# SERVICE BULLETIN

M-900

January 18, 1985

## 1985 MODEL FXST SHOCK ABSORBER BOLTS

**Figure 1. Torque Wrench with Adaptor**

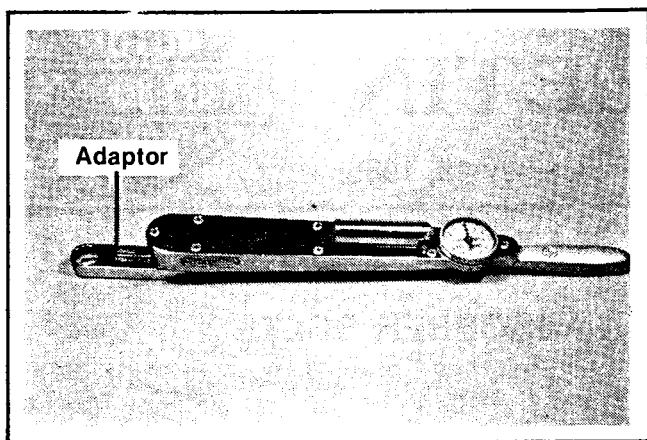
FXST shock absorber bolt torquing procedure requires the use of a SNAP-ON ADAPTOR, Part No. SRES 24, to allow accurate torquing. See Figure 1.

Bolt torque must be computed because the adaptor effectively lengthens the torque wrench. A TORQUE COMPUTER is available from Snap-on, Part No. SS-306D, for use when an adaptor or extension is added to any torque wrench. The computer can easily be used with dial or click type torque wrenches.
